Wollongong Local Planning Panel | 21 May 2020

WLPP No.	Item No.2
DA No.	DA-2019/1375
Proposal	Residential - Demolition of existing structures and construction of a residential flat building
Property	2 Market Place, WOLLONGONG
Applicant	ADM Architects
Responsible Team	Development Assessment and Certification - City Centre Team (NL)

ASSESSMENT REPORT AND RECOMMENDATION

Figure 2: Sun plane protection diagram

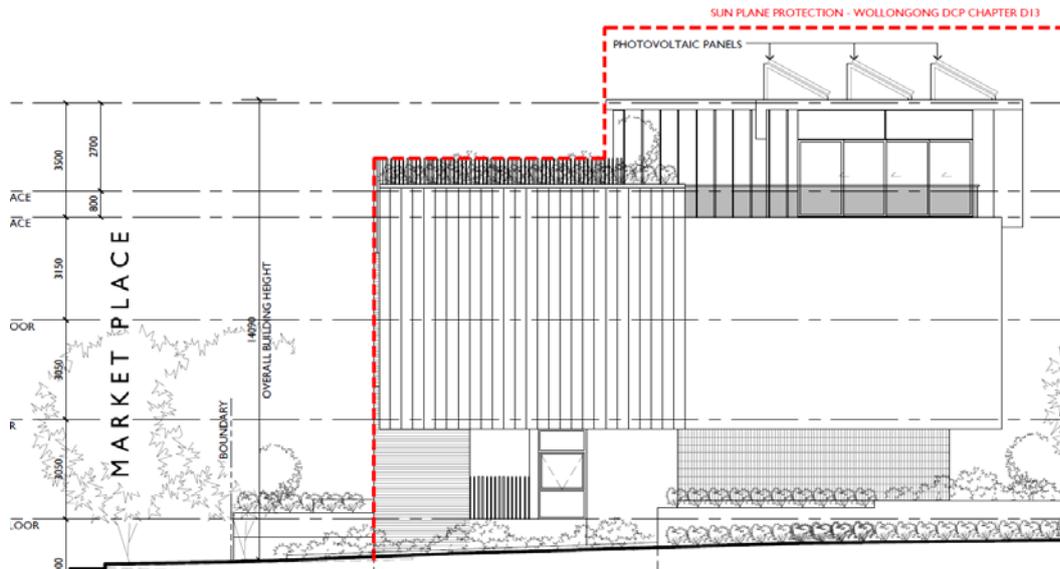
$12 + (0.6061 \times (11.175 - 4)) = 16.3\text{m}$. The height of the roof level is 14.3m.

The building complies with the sun plane protection controls as illustrated above and, in the sketch below.

EAST ELEVATION

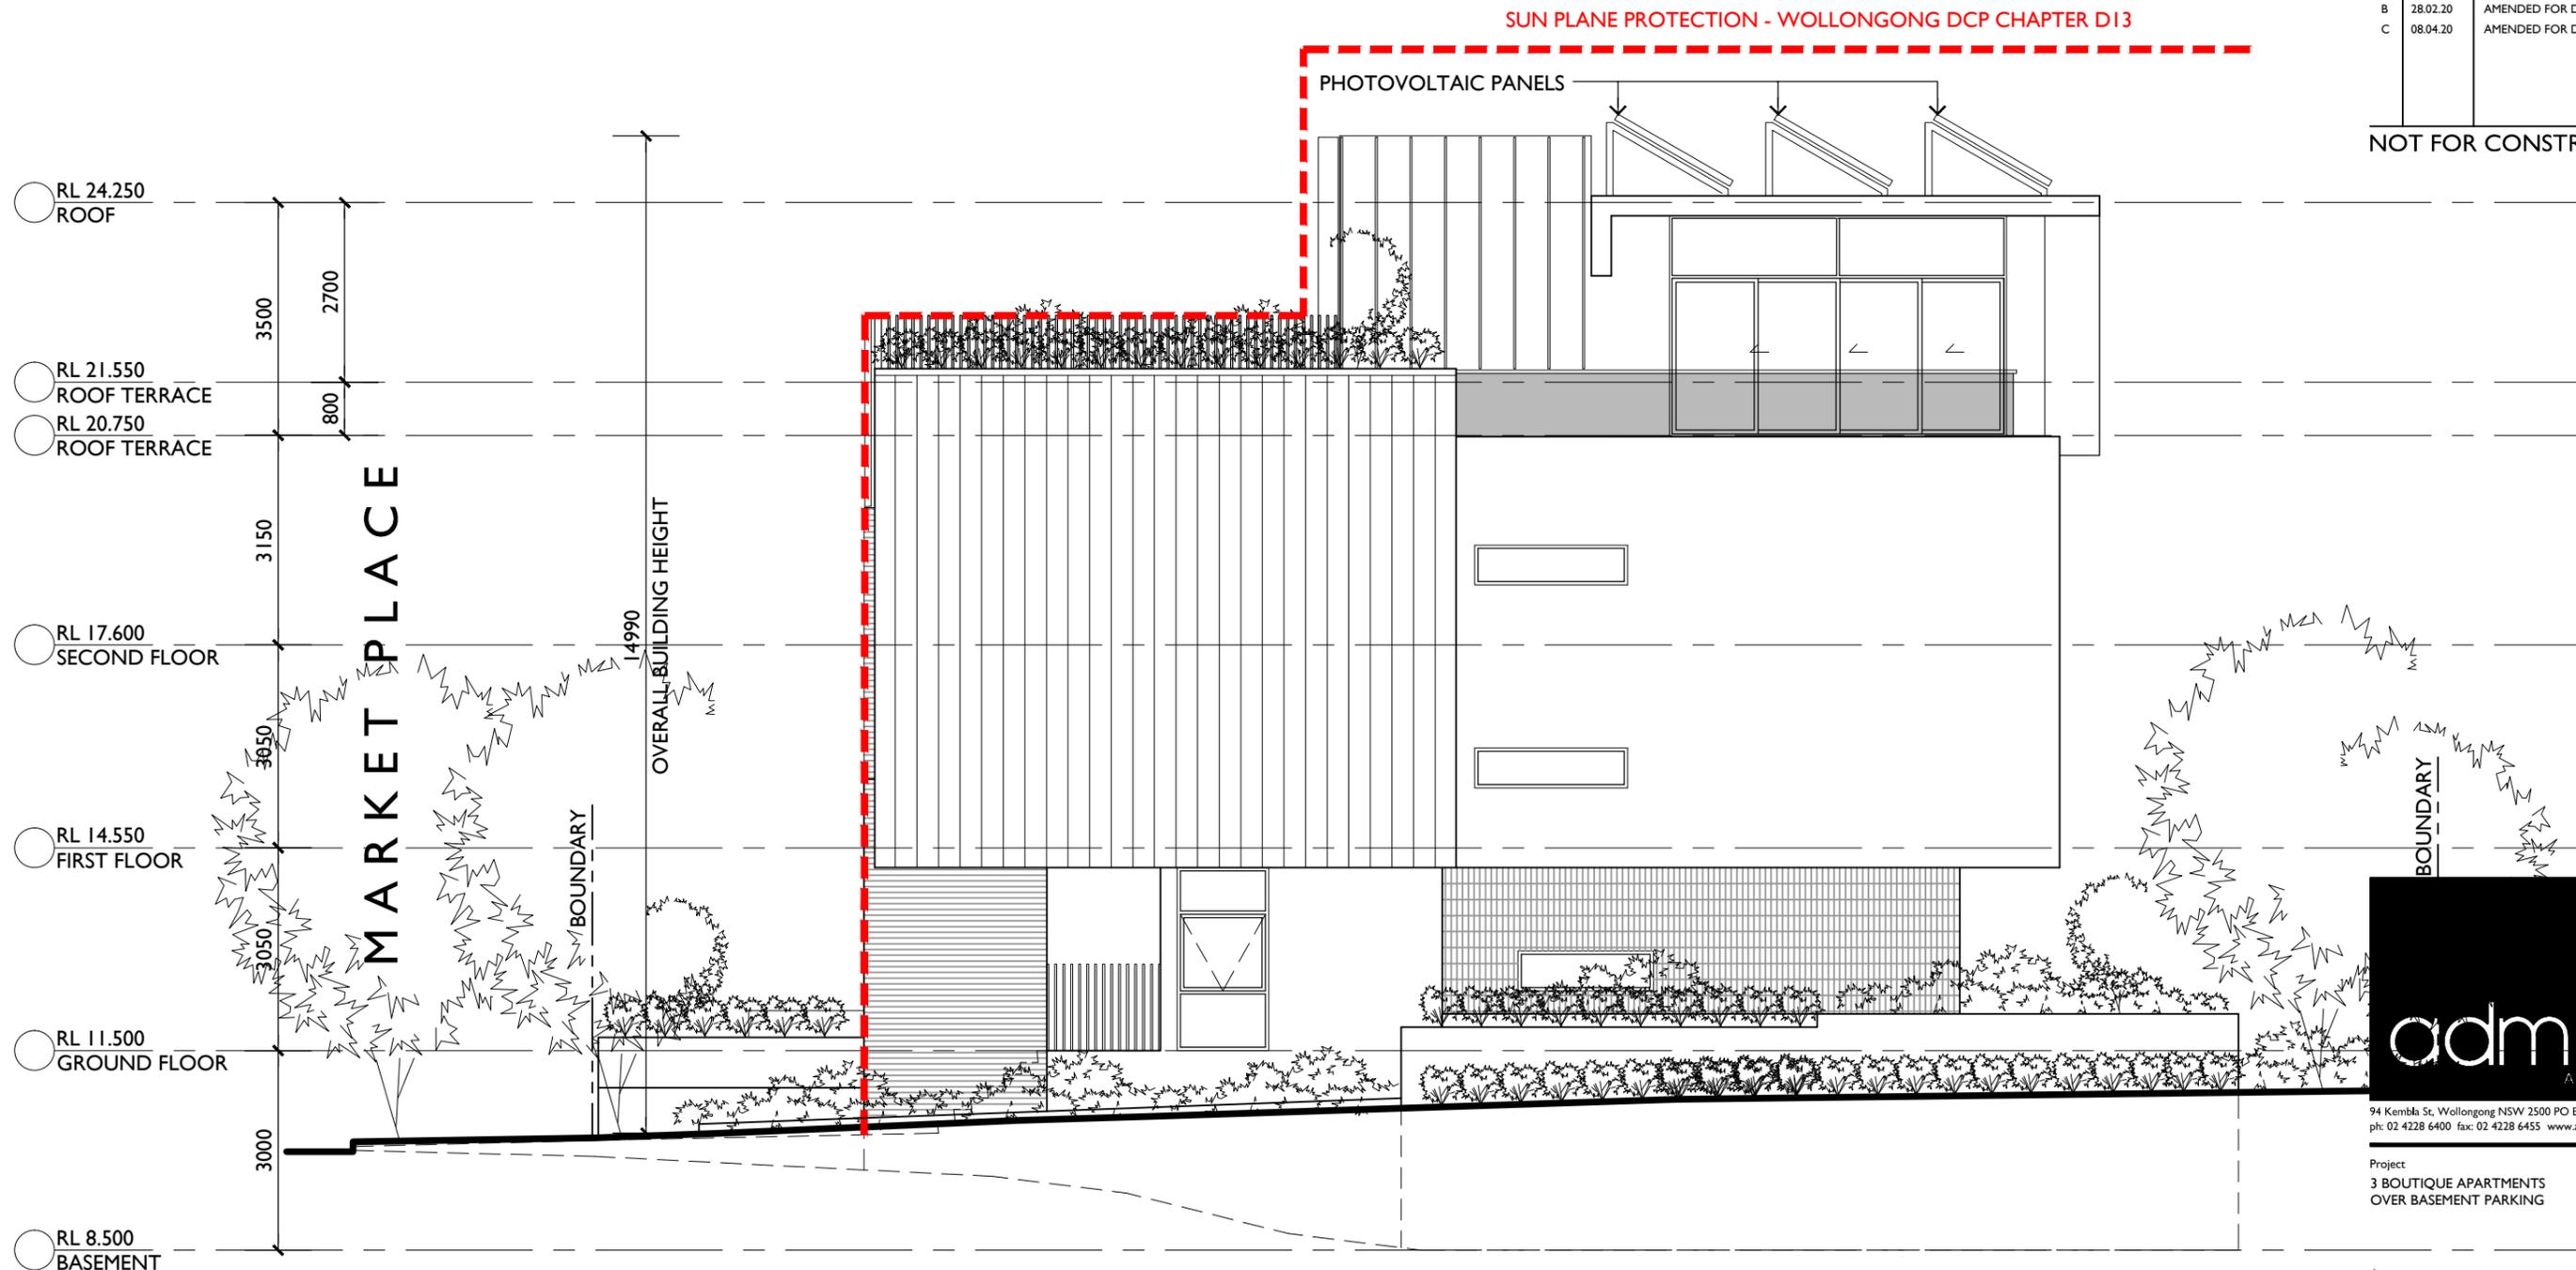
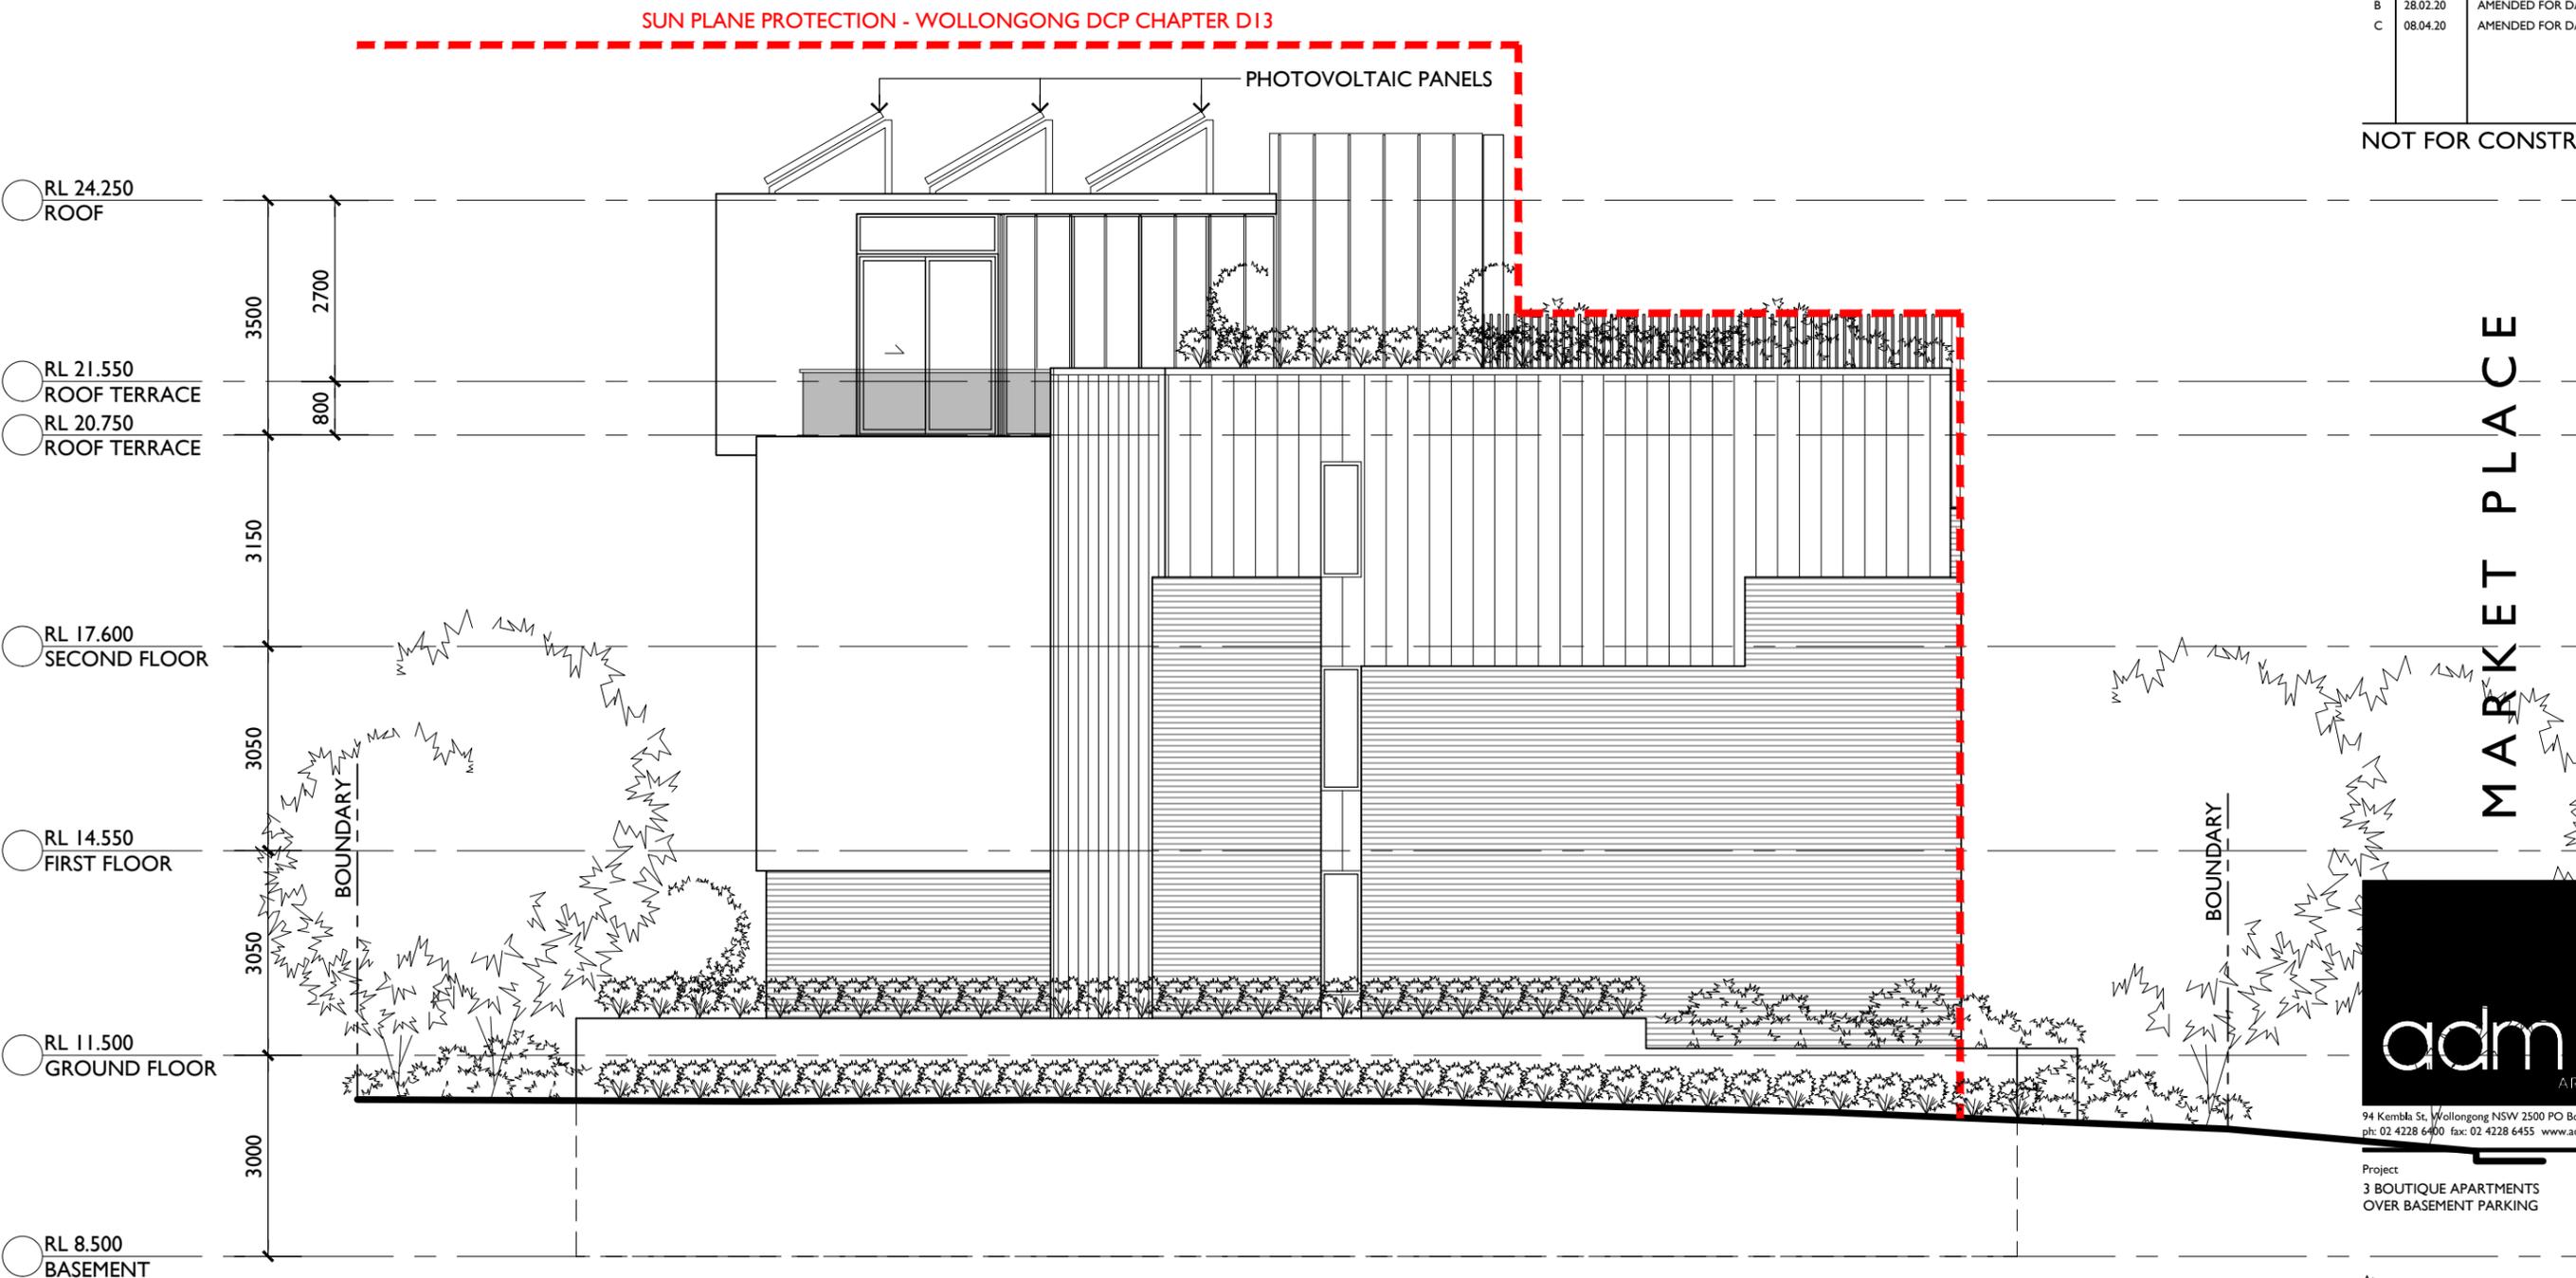
<p>The proposed roof terrace servicing unit 3, consolidates its built form mass centrally on the building, providing 6m setbacks to both the eastern and western side boundaries and extending its roof form to align with the street façade. The resultant form does not comply with council's sun plane requirements, as set out in WLEP.</p> <p>The form of the roof level terrace must be developed to address this issue.</p>	<p>The roof terrace level has been redesigned to comply with WLEP. This has been achieved by setting back the building line 11.175m from the southern boundary as shown on drawing A-106.</p> <p>Compliance is demonstrated on the east and west elevations on drawings A-202 and A-204.</p>
